SUBJECT: Transmittal of Class 1 Permit Modification Request to Include Dome 224 within the Los Alamos National Laboratory Hazardous Waste Facility Permit

**Class 1 Permit Modification Request to Include Dome 224 at
Technical Area 54, Area G, Pad 5 within the Los Alamos
National Laboratory Hazardous Waste Facility Permit**

Class 1 Permit Modification Request to Include a Structure at Technical Area 54, Area G, Pad 5

Figure G.8.1 Technical Area 54, Area G, Pad 5, Outdoor Container Storage Unit Soil Sampling Grid and Additional Sampling Locations

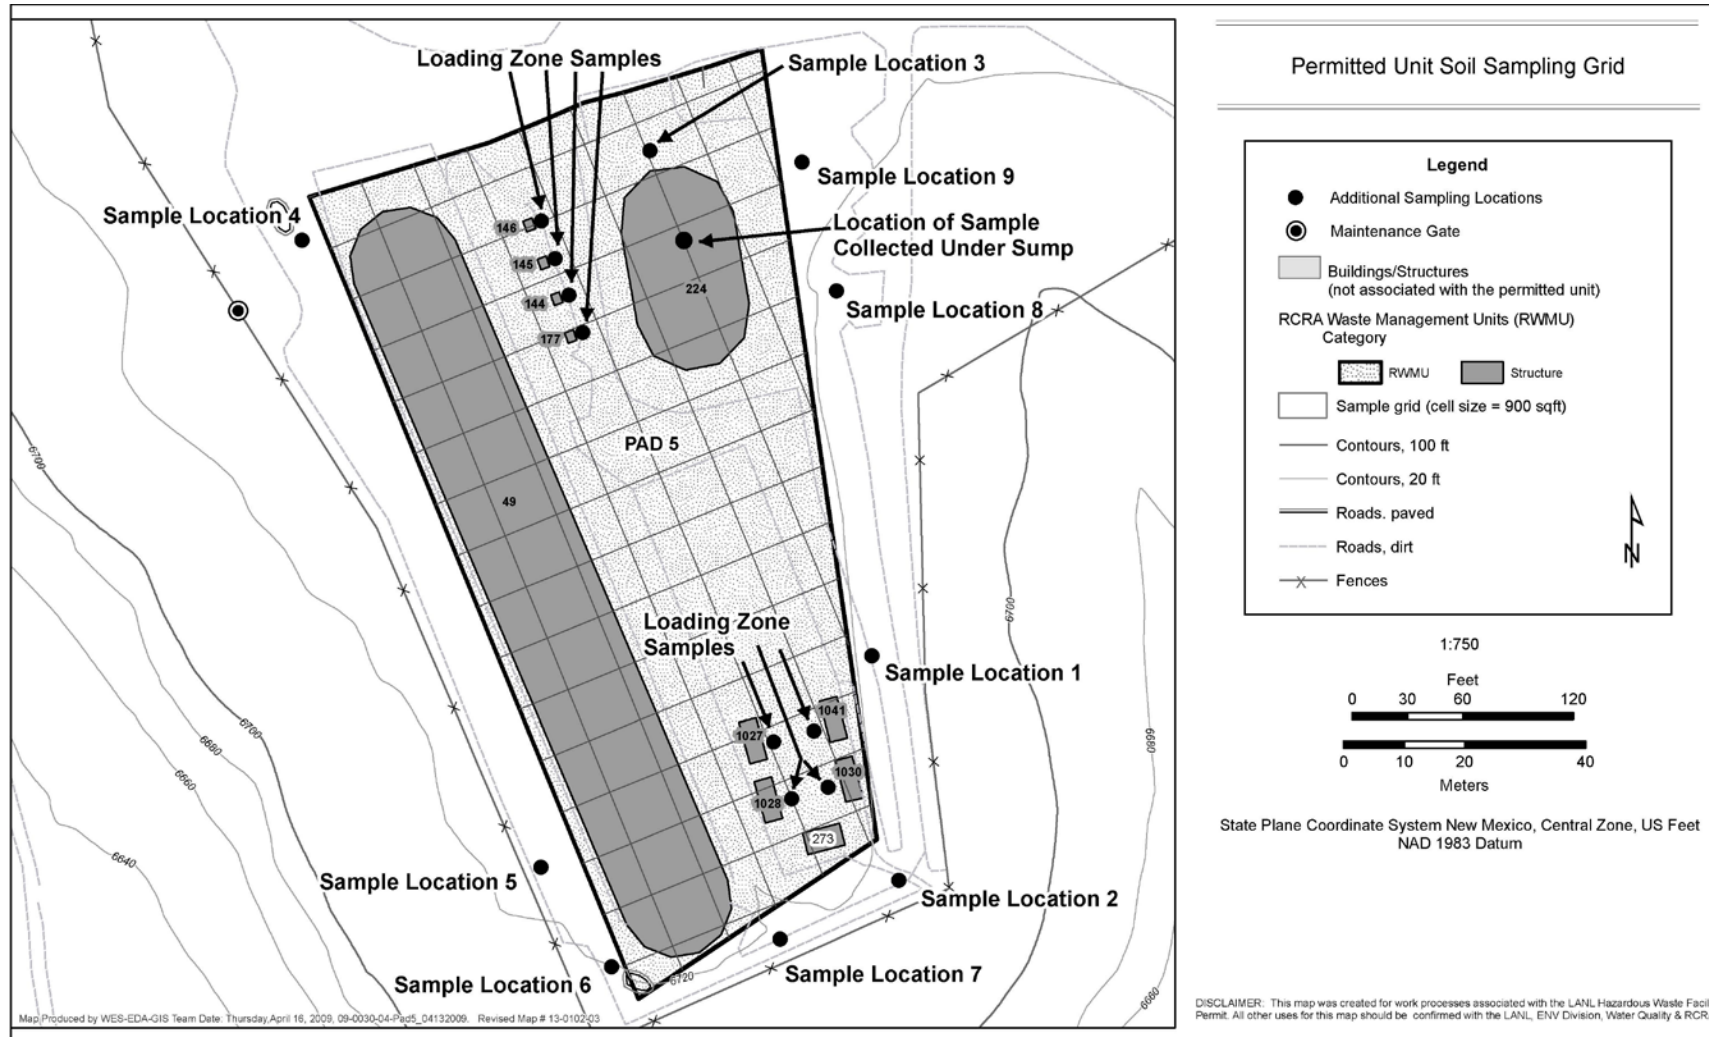
Proposed changes revert to the language within the closure plan as it was prior to the request for removal of the dome from the permitted unit. The description of the dome within Section 2.0, *Description of Unit to be Closed*, was changed to present tense and additions were included in Section 6.1, *Soil Sampling and Decontamination Verification Sampling Activities*. None of the required sample locations have been changed from the approved closure plan, and the Dome 224 footprint has been included on Figure G.8.1: *Technical Area 54, Area G, Pad 5, Outdoor Containers Storage Unit Soil Sampling Grid and Additional Sampling Locations*.

Figure G.9-1: Technical Area 54, Area G, Pad 6 Outdoor Container Storage Unit Sampling Grid and Additional Sampling Locations

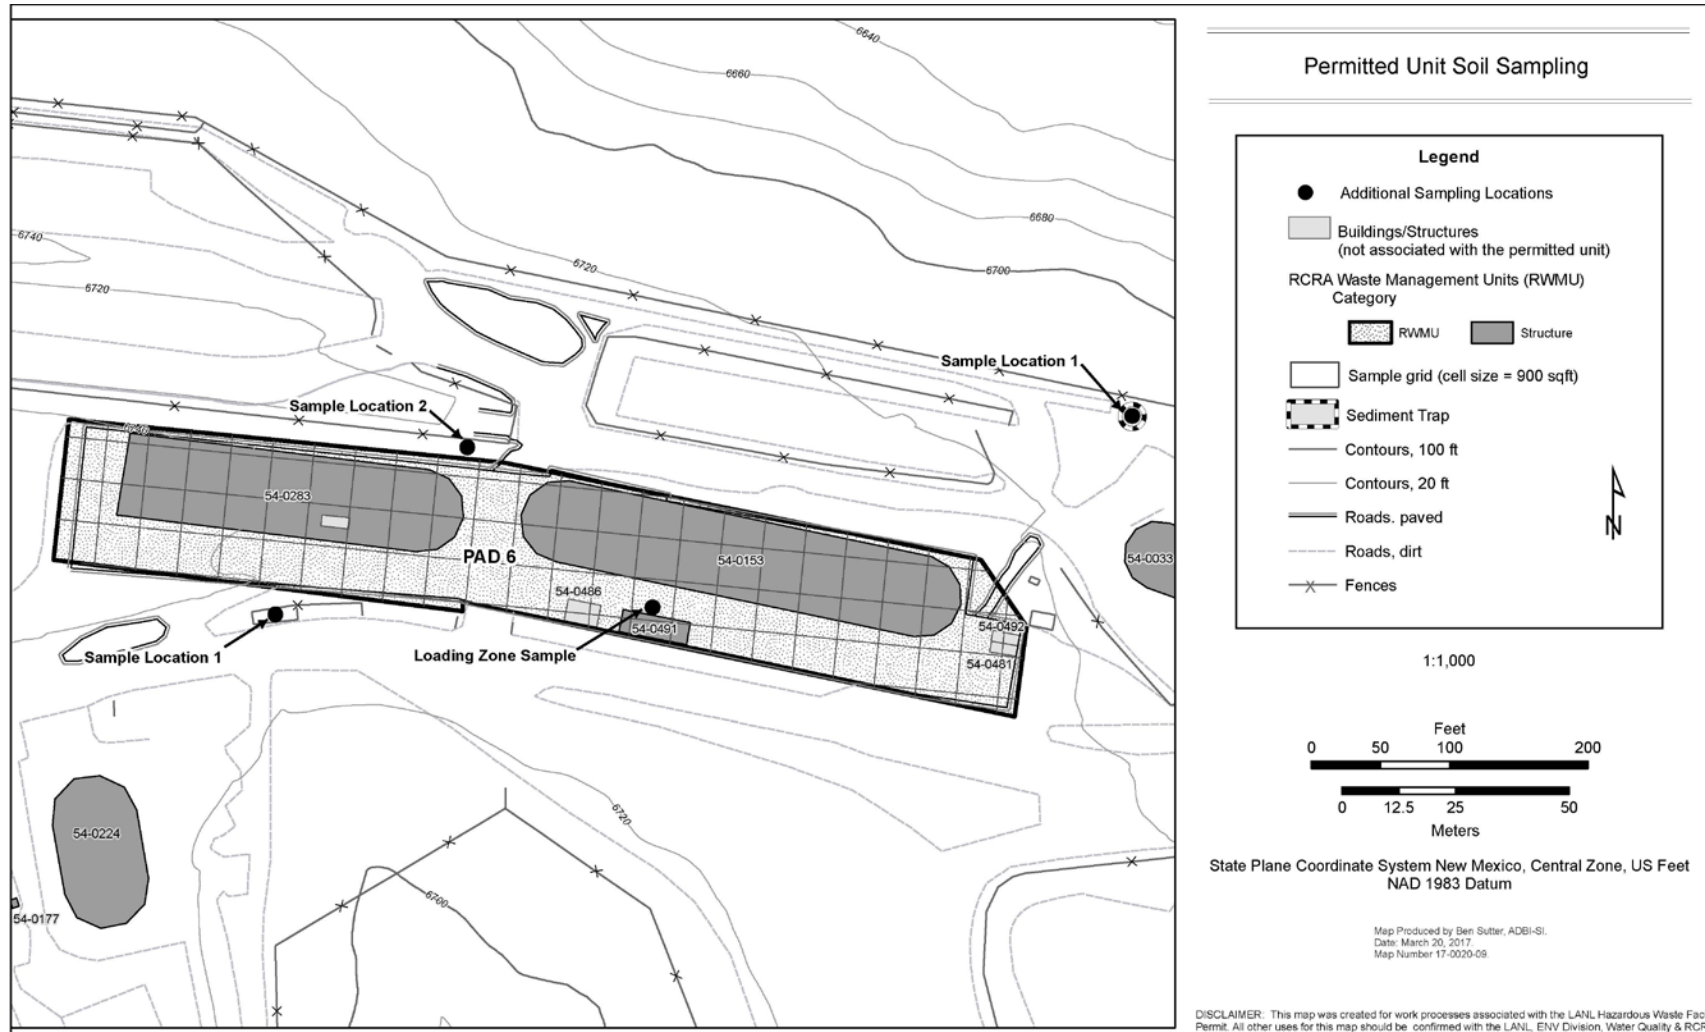
Figure G.9-1: *Technical Area 54, Area G, Pad 6 Outdoor Container Storage Unit Sampling Grid and Additional Sampling Locations* has been revised to include Dome 224 at Technical Area 54, Area G, Pad 5.

Figure 8: Technical Area 54, Area G, Security Fences, Entry Gates, and Entry Stations

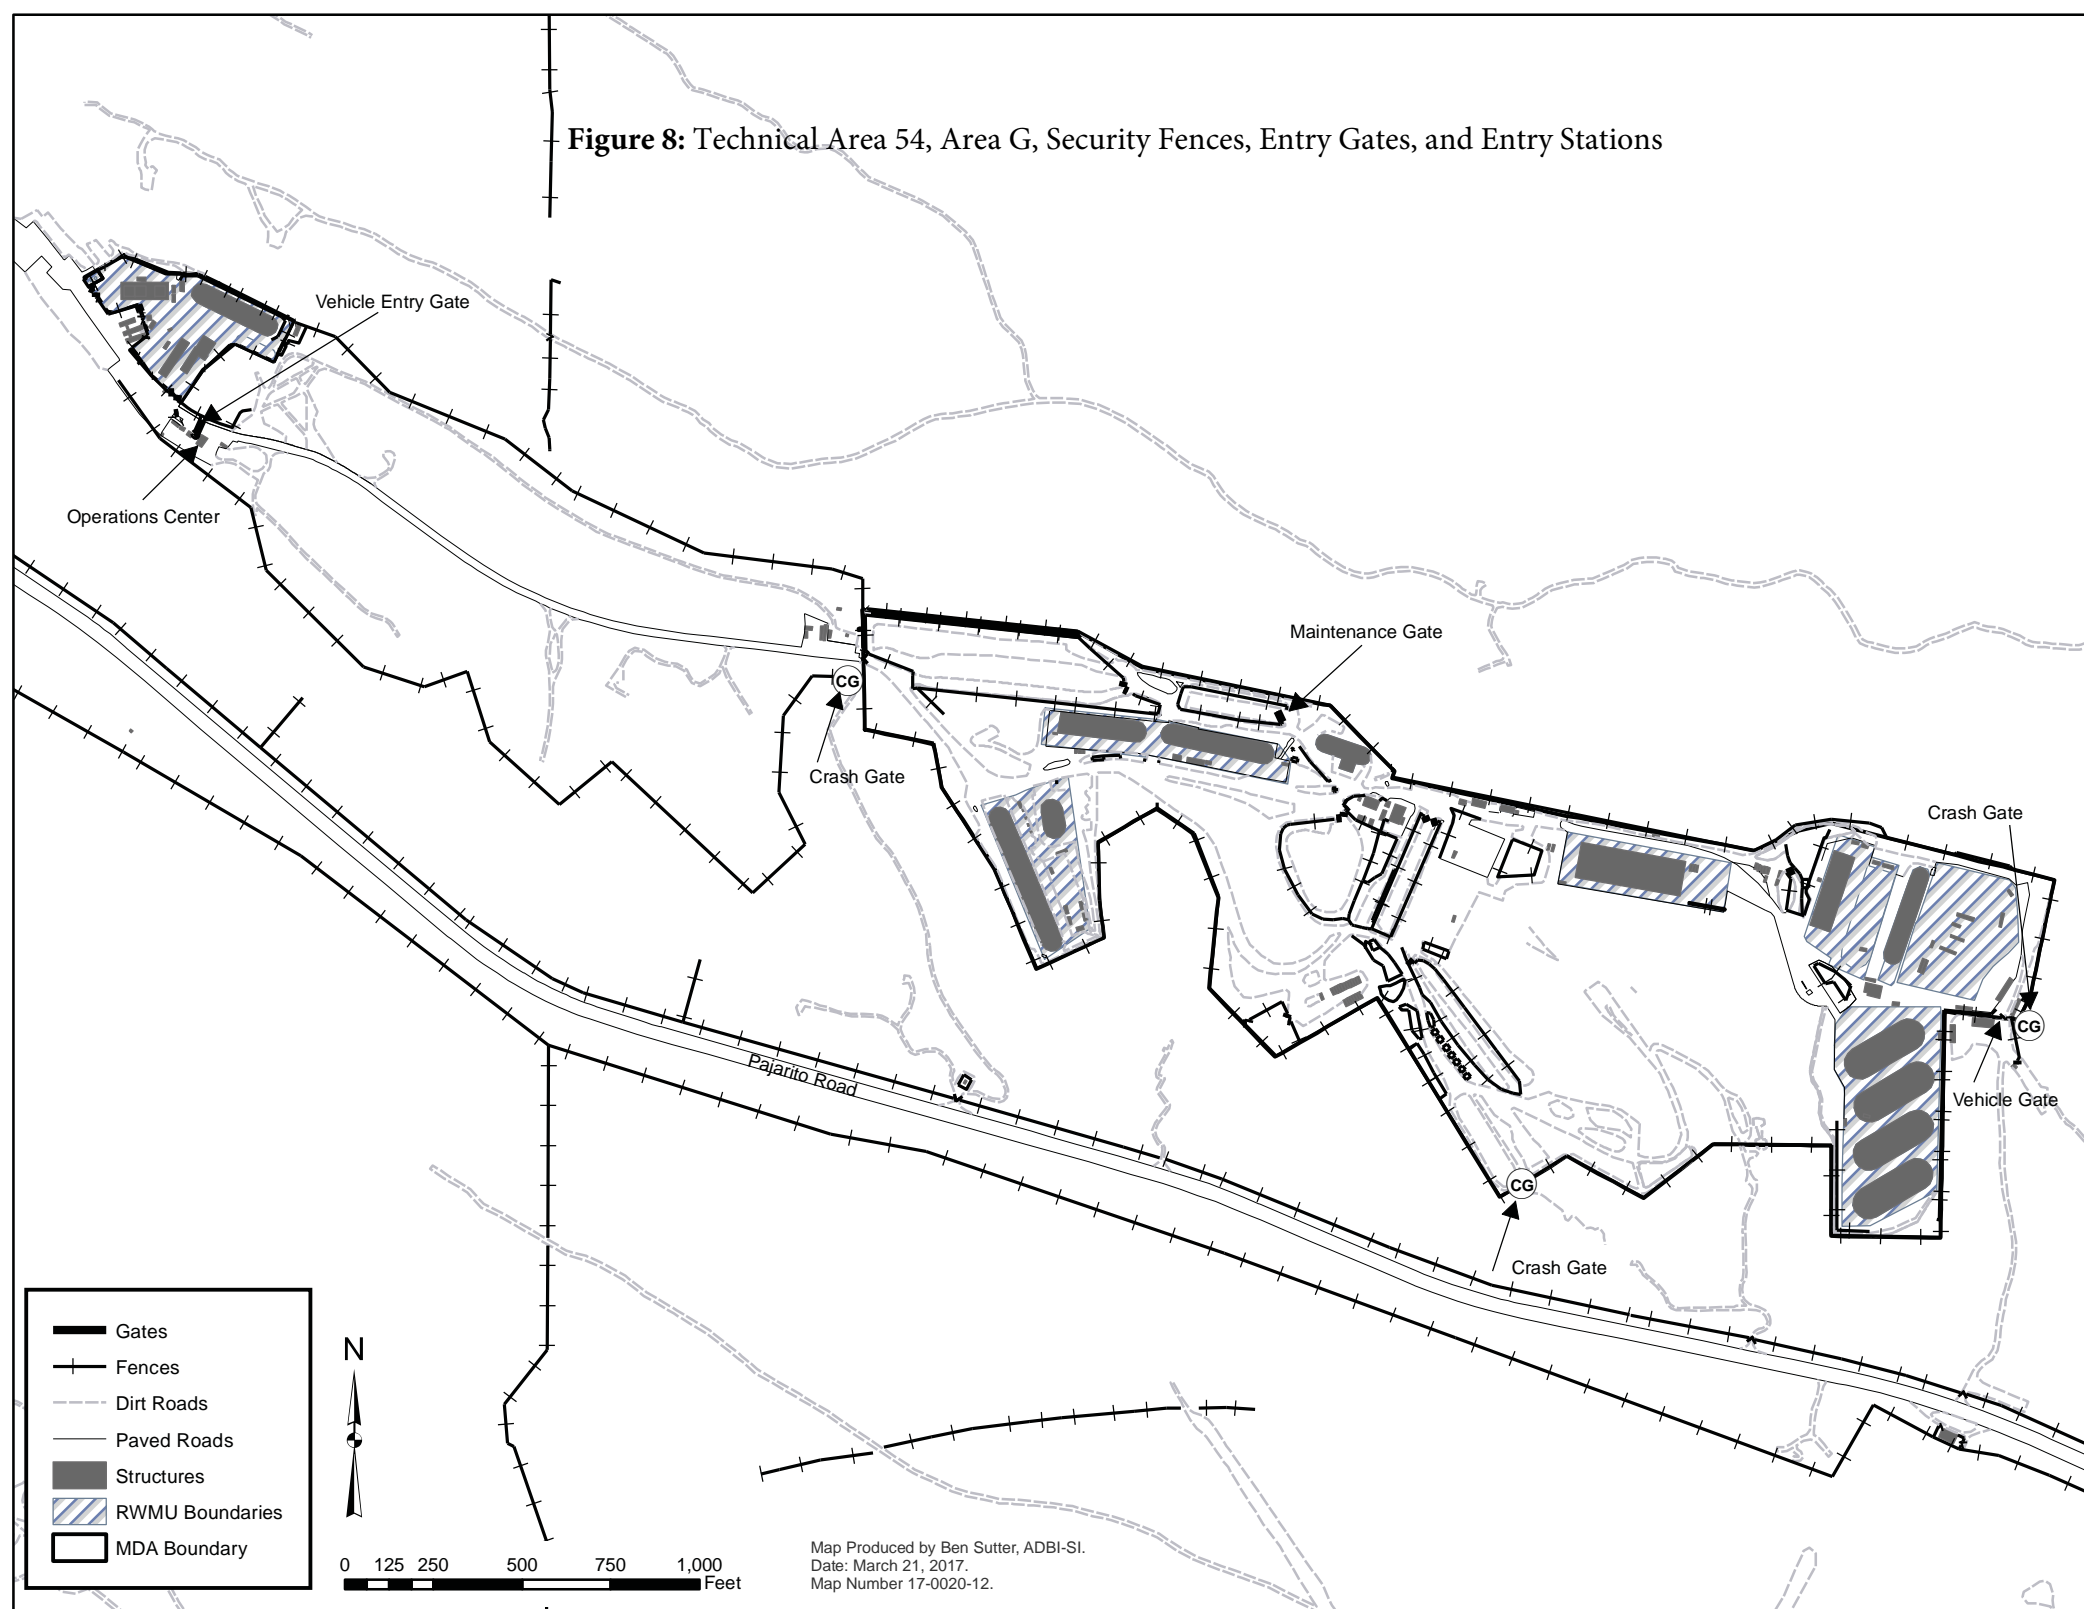
Figure 8: *Technical Area 54, Area G, Security Fences, Entry Gates, and Entry Stations*; Figure 27: *Technical Area 54, Area G, Container Storage Units*; and Figure 33: *Technical Area (TA)-54, Area G, Pad 6, (Domes 153 & 283)* were revised to include Dome 224. Also, Figure 32 within Attachment N was revised to include the Dome 224 structure on the permitted unit and the title of the figure was changed to “Figure 32: Technical Area (TA)-54, Area G, Pad 5 (Domes 49 and 224; and Storage Sheds 114, 145, 146, 177, 1027, 1028, 1030, and 1041)”.
